QUALITY AUDIT REPORT

Project: **PUBLIC REALM IMPROVEMENTS FOR
A PEDESTRIANISED NEW STREET**

Project no.: **Fc.03**

Prepared by: **DFLA**

3.1.1 Problem – Seating and Litter Bin

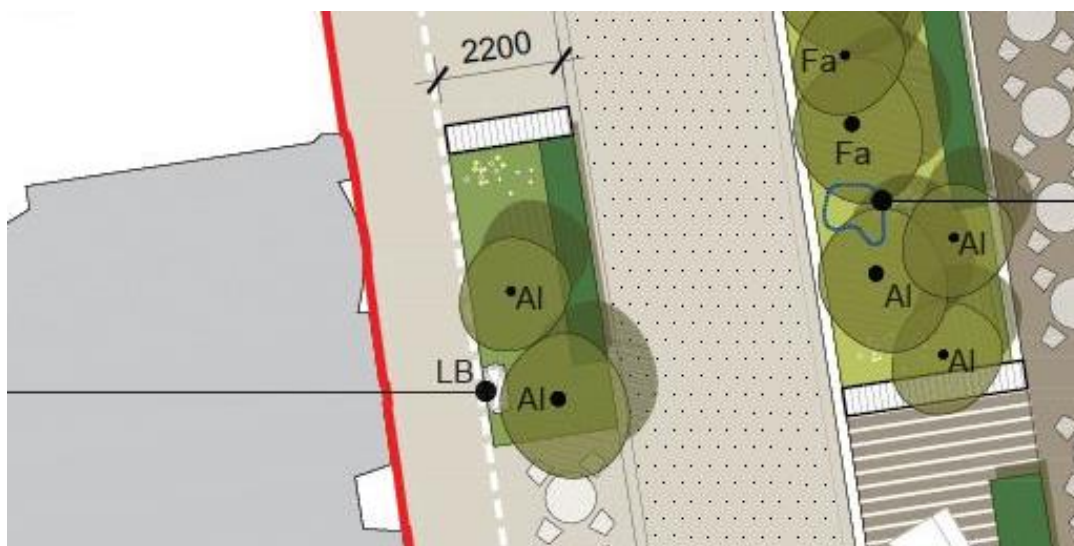
The bin is located within 3 metres of seating and may create discomfort to the user with odours and insects.

Move the bin so that it is 3m away from all seating areas.

3.1.1	Y	Y	N/A	N/A
3.1.2	Y	Y	N/A	N/A
3.1.3	Y	N	To be developed and co-ordinated at detail design stage with FCC	Y
3.2.1	Y	Y	A review has been carried out. The corners present are an existing condition. Confirmation has been provided from Axiseng that the street lighting will be at an appropriate level. The street is very open and will have good visibility in all directions generally.	Y

3.1.2 Problem – Resting at Crossing Points

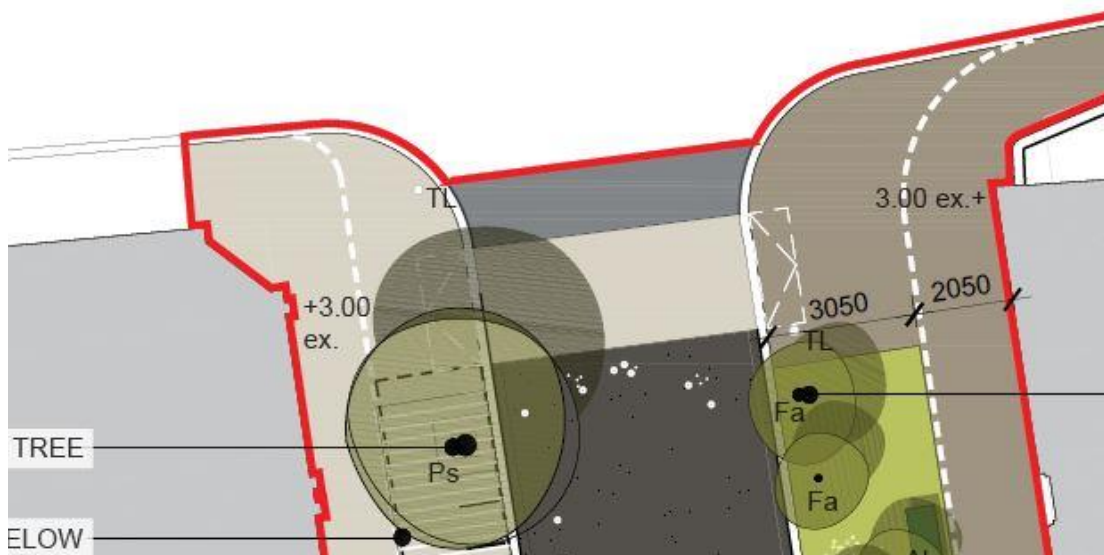
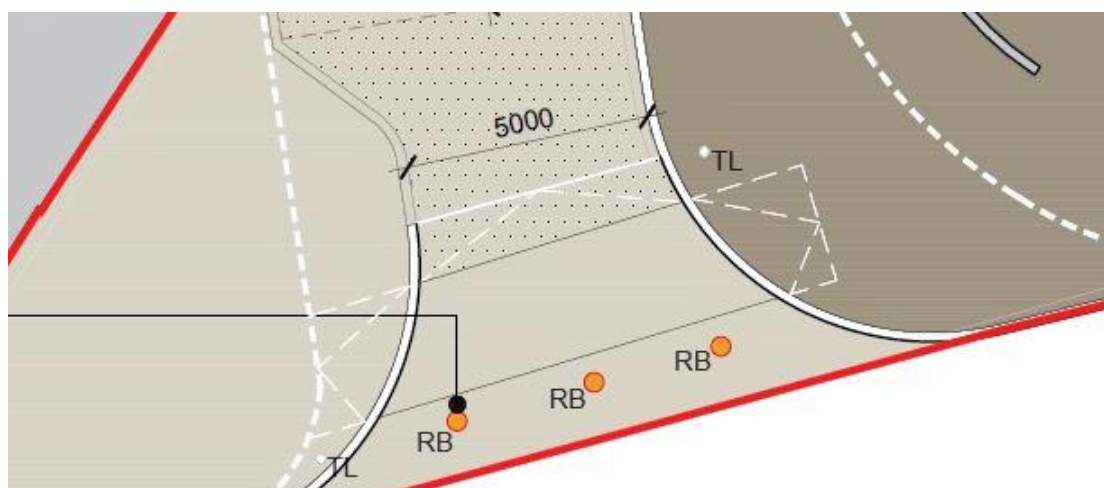
It is proposed to provide 2no. pedestrian crossings at either end of the street. No resting post or seating is located near to the crossings. This is recommended for older people when waiting for an opportunity to cross.

It is recommended that a seat or leaning post is provided on both sides of the street at both crossings.

3.5.2 Problem - Accessibility

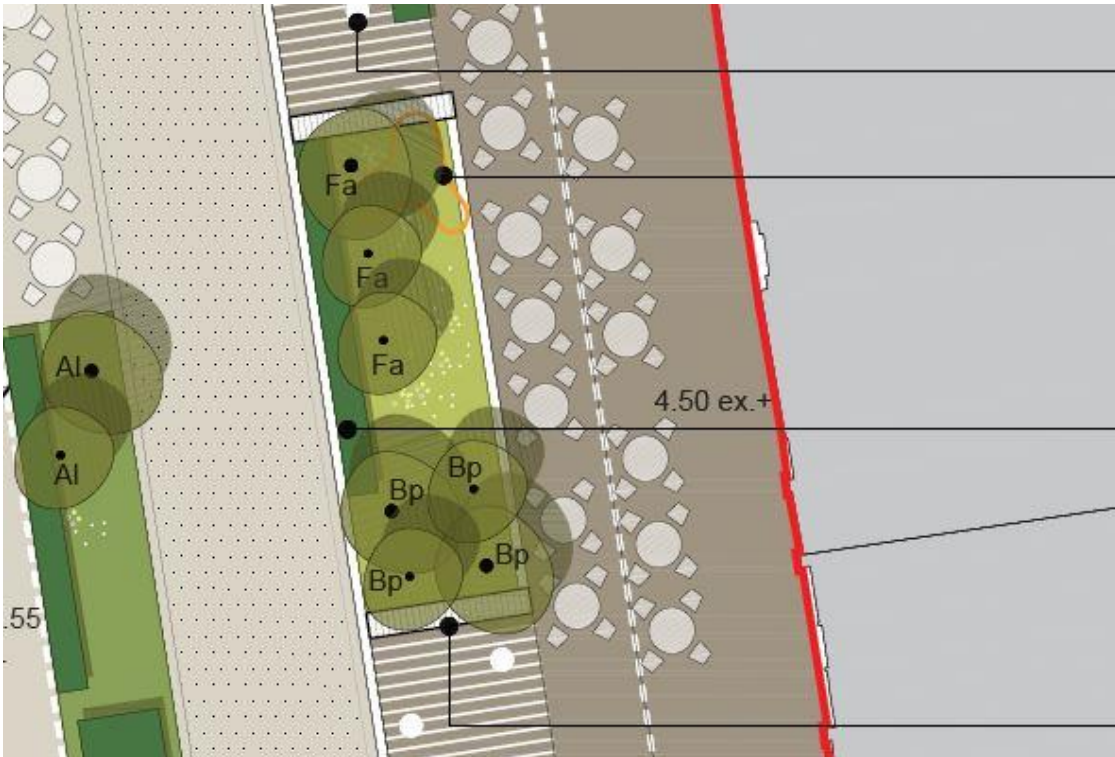
It was noted that people who are visually impaired should be able to easily navigate around seating areas, and that their location in the current plan, on the outside of the path, might compromise this.

Seating in this area could be removed to facilitate safer movement for visually impaired users or clear delineation could be provided in the design proposal.

3.5.2	Y	Y	Delineation will be shown to this area in drawing Fc.03-DR-2001	Y
3.5.3	Y	Y/N	The quantity of cycle parking is considered appropriate for the size of the street. Signage will be provided at detail design stage for cyclists to dismount.	Y

3.5.3 Problem – Pedestrian Safety

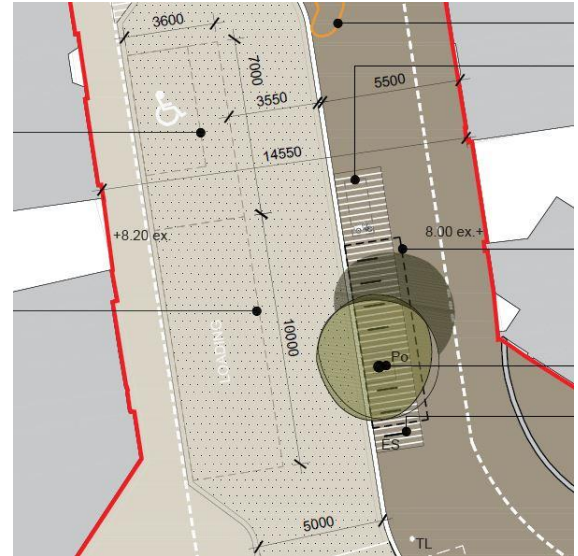
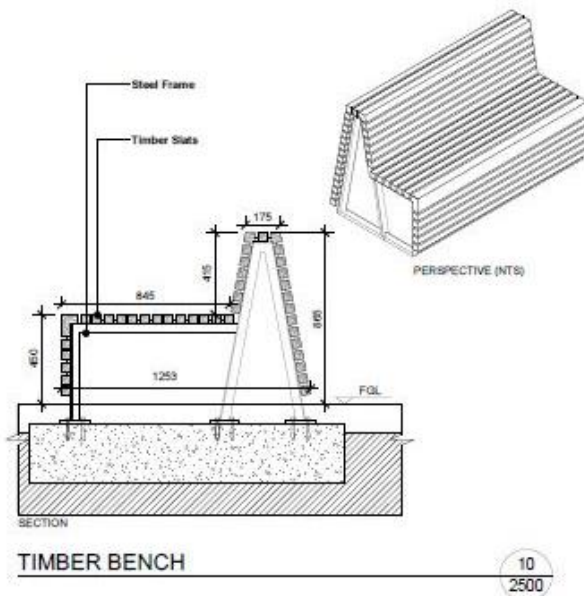
More bike parking at either end of the street and signage for cyclists to dismount was frequently requested.

It is recommended that more cycle parking be proposed and signage be provided.

3.5.7 Problem - Heritage

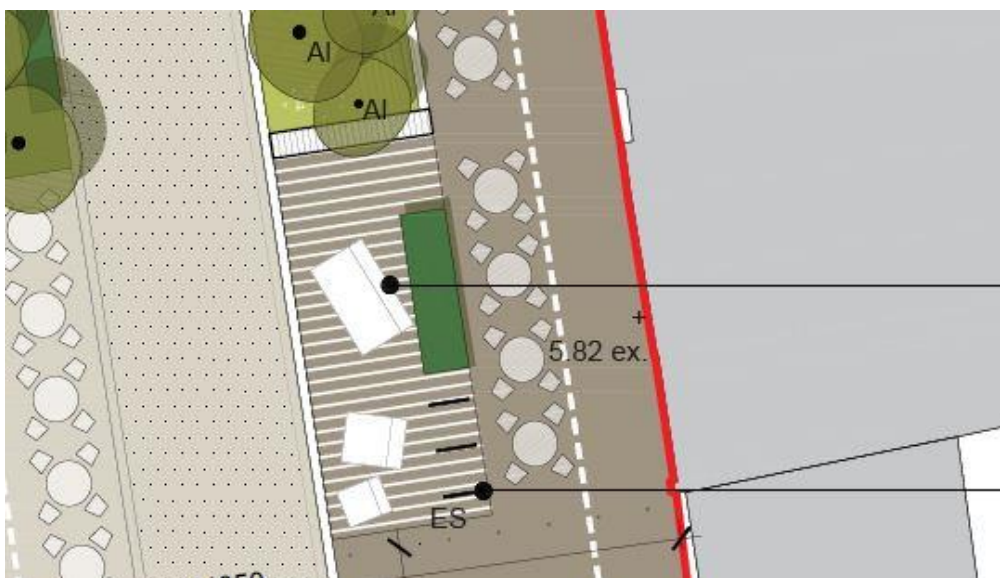
Signage or paving stone to mark the history and heritage of New Street was requested

It is recommended that historical information displayed in paving material be considered as part of the proposal, as suggested in Design Rationale.

3.5.6	Y	Y	Small tables will be provided to public seating at detail design stage.	Y
3.5.7	Y	Y	As noted in the Design Rationale by DFLA, this will be provided in the design. This will be considered at detail design stage.	Y
